RE: 150 Steeles Avenue East and 248, 250 & 314 Martin Street, Milton, Proposed Mixed-Use Development

This memorandum is intended to provide additional information to address the Town’s transportation-related comments dated April 2, 2026 and April 8, 2026, and the Region’s transportation comments dated April 17, 2026, in regard to BA Group’s February 2026 Transportation Considerations Report (“the February 2026 BA Group Report”). We trust that the enclosed memorandum provides the appropriate information requested by the Town. Please feel free to let us know if you have any questions or require any additional information.

1.0 BA GROUP RESPONSES TO TOWN COMMENTS

INBOUND

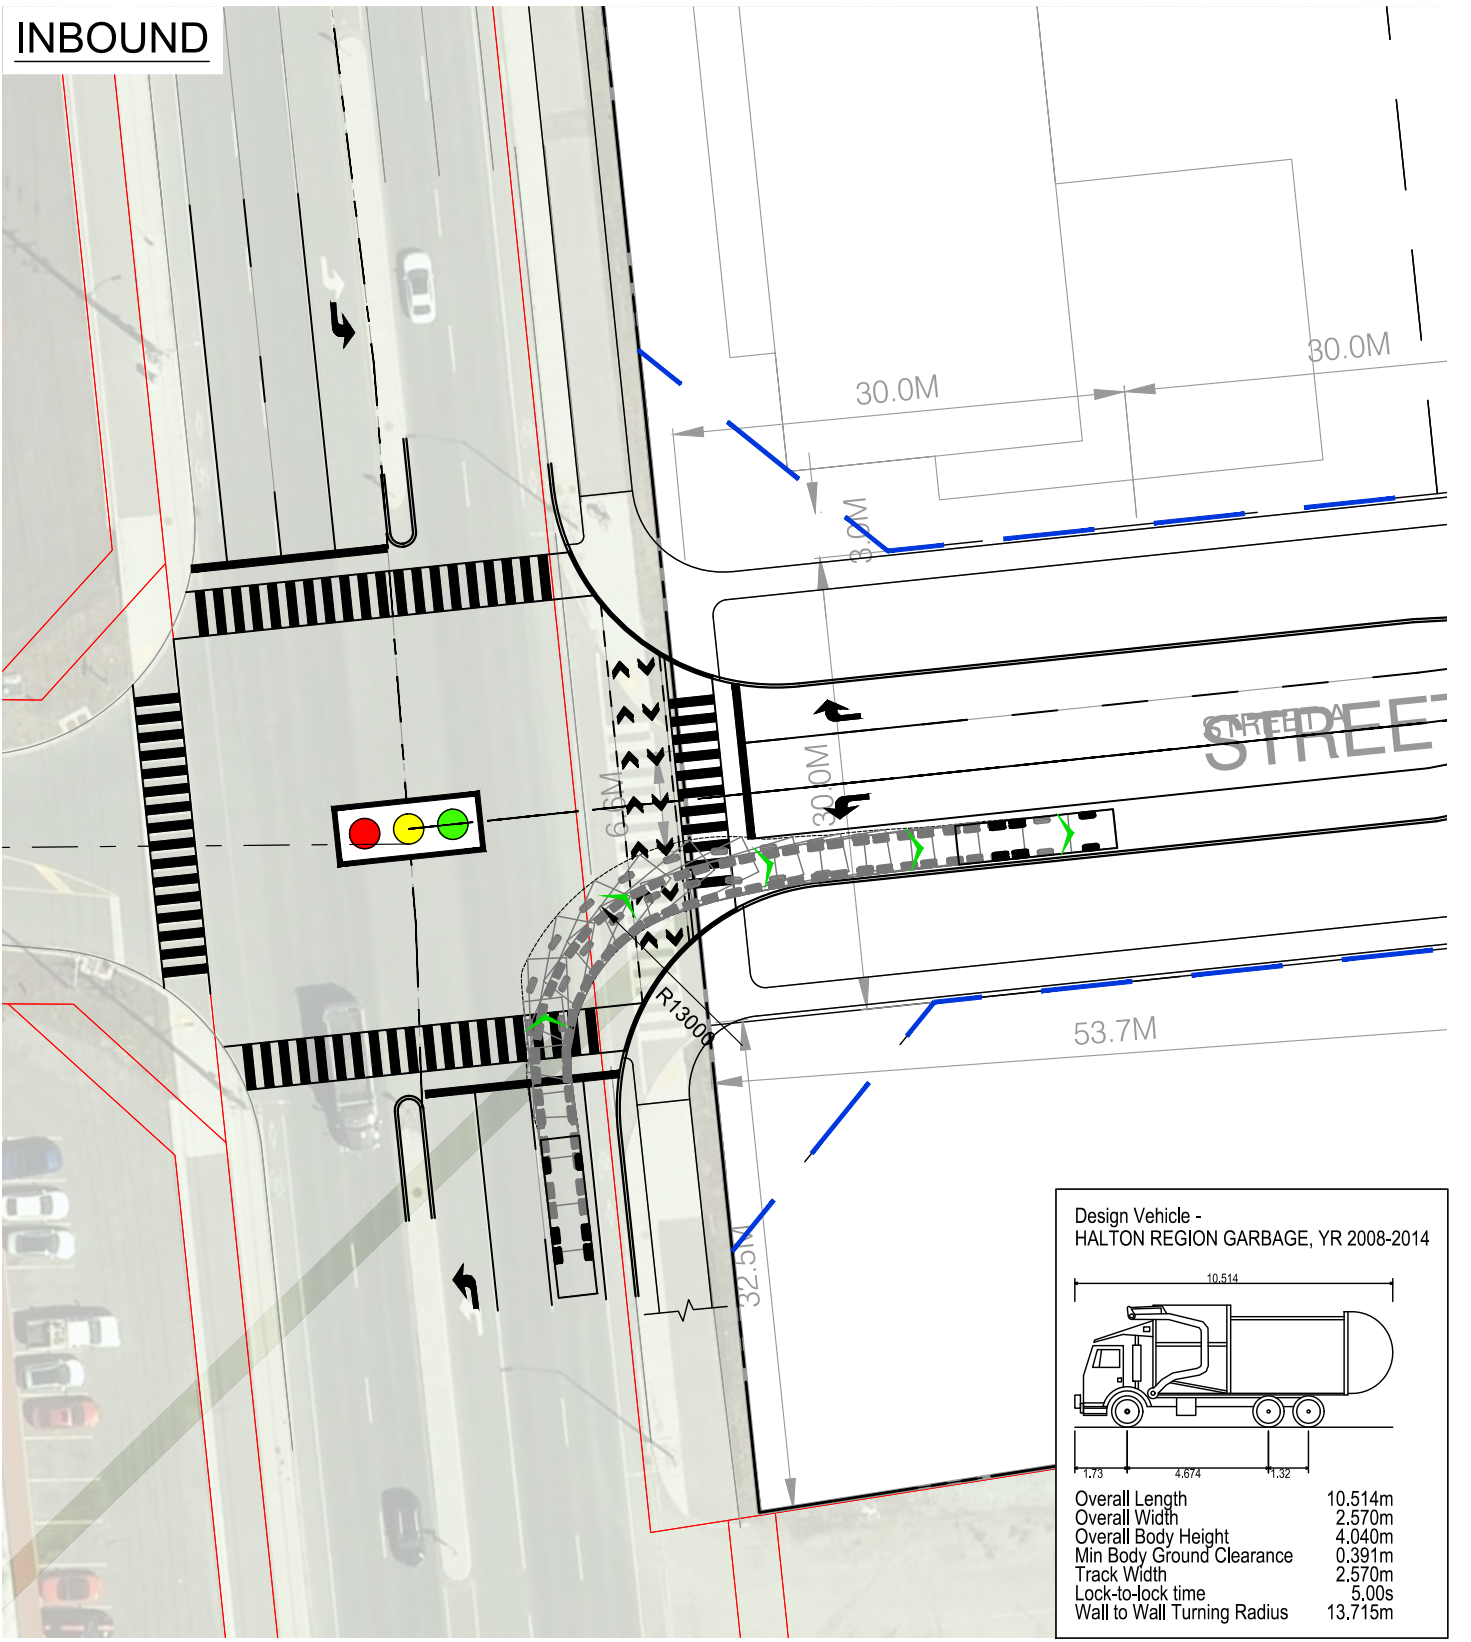
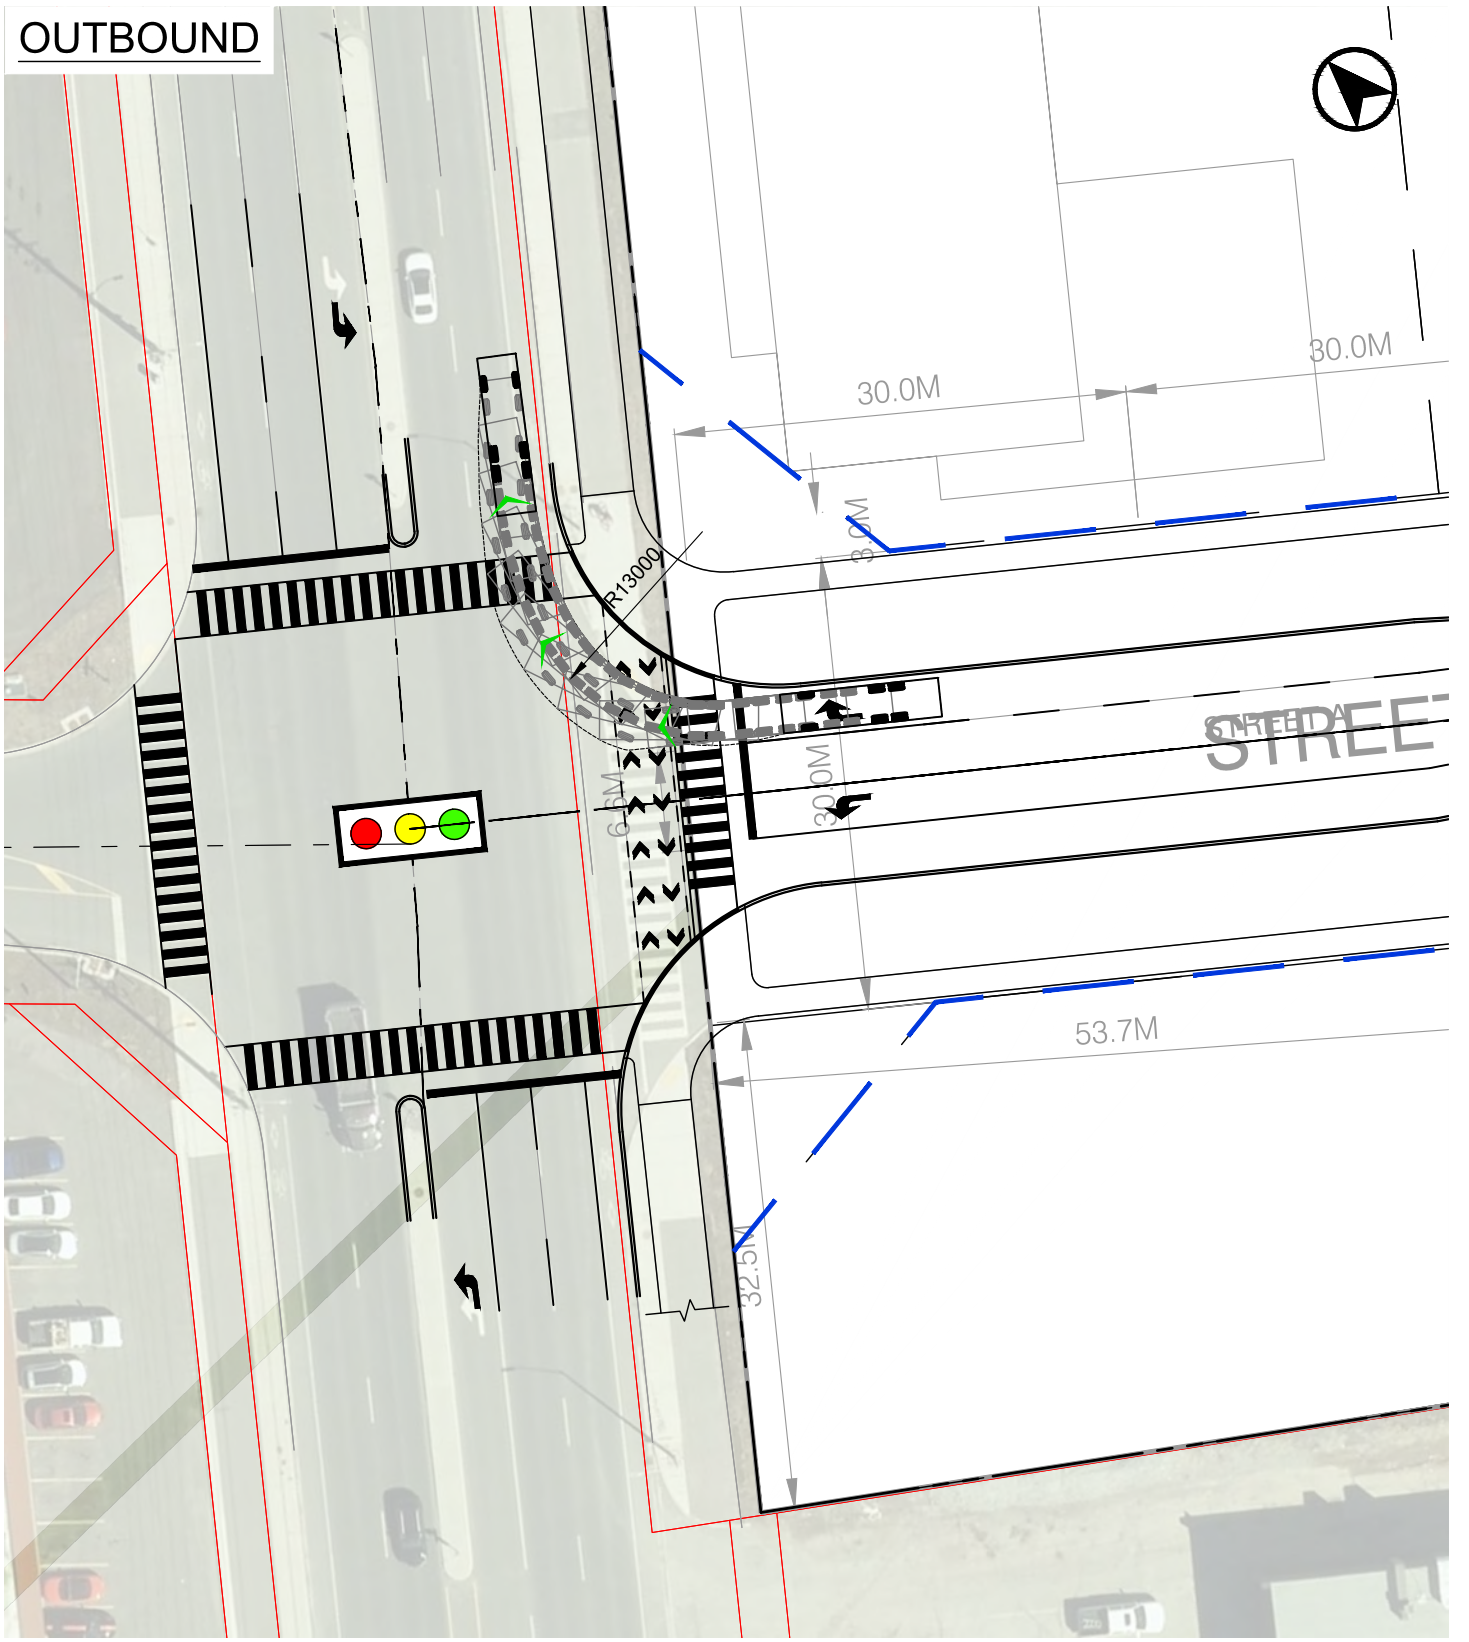
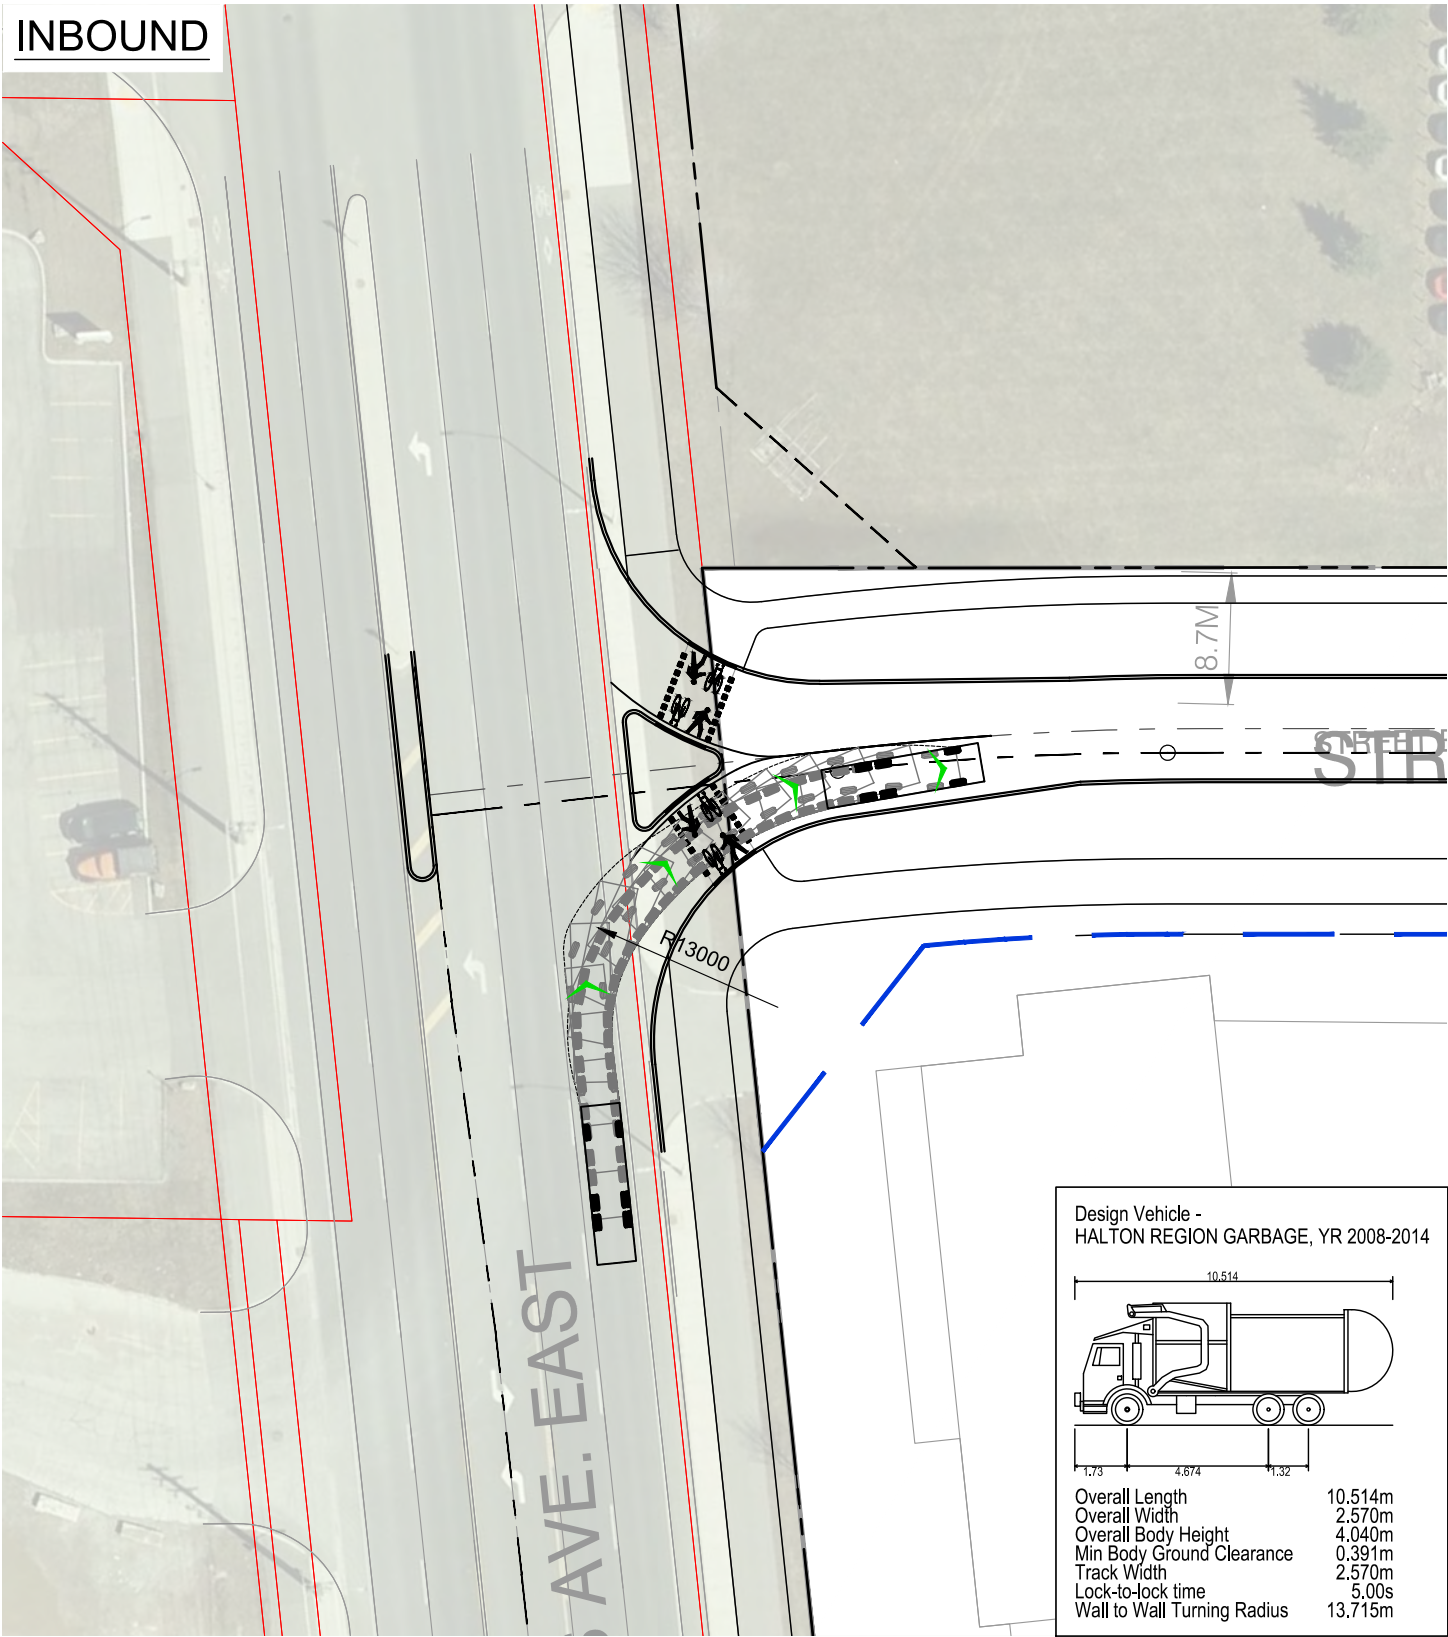
Comment: Please indicate the centreline turning radius in all locations where the waste collection vehicle is turning and approaching loading area (minimum 13 metres).

Comment: Please indicate the length of the head-on approach (minimum 18 metres).

Comment: Please indicate the distance the waste collection vehicle will be required to reverse (maximum 18 metres).

Comment: Please indicate the waste collection vehicle route from the municipal road to the Collection Point and back to the municipal road. Please ensure to include the turning radius of all turns.

Comment: Where continuous forward movement of waste truck cannot be achieved, a cul-de-sac or T-turnaround may be permitted if 13m turning radius and max 18 metre backup distances can be met.

Comment: Notwithstanding the loading requirements set out in the Town 's Zoning By-law, the loading spaces in Phase 1 of the development are proposed to be 12 m x 3.5 m (overhead waste collection) in size.

- All dimensions on the below loading areas including centre line turning radii.
- One truck maneuvering diagram. The overlay provided below makes it difficult to determine the path of the collection vehicle.

Response: The centreline turning radius of a minimum of 13 metres is illustrated on the Vehicle Manoeuvring Diagrams (VMDs) attached in **Appendix C**.

Response: The 18 metres head-on approach is illustrated on the VMDs attached in **Appendix C**.

Response: The reversal distance of the waste collection vehicle is illustrated on the VMDs attached in **Appendix C** and illustrate reversal distances of 18 metres or less.

Response: VMDs provided in **Appendix C** illustrate waste collection vehicles entering each block from the municipal road and leaving each block onto the municipal road.

Response: VMDs provided in **Appendix C** illustrate waste collection vehicles entering and existing each site in a forward motion. The turning radius (minimum 13 metres) and the reversal distances (maximum 18 metres) are illustrated on the VMDs.

Response: Vehicle Manoeuvring Diagrams provided in **Appendix C** illustrate the waste collection vehicle entering and exiting the proposed waste collection areas with dimensions (minimum 13 metres turning radius, minimum 18 metres head-on approach and maximum 18 metres reversal distance).
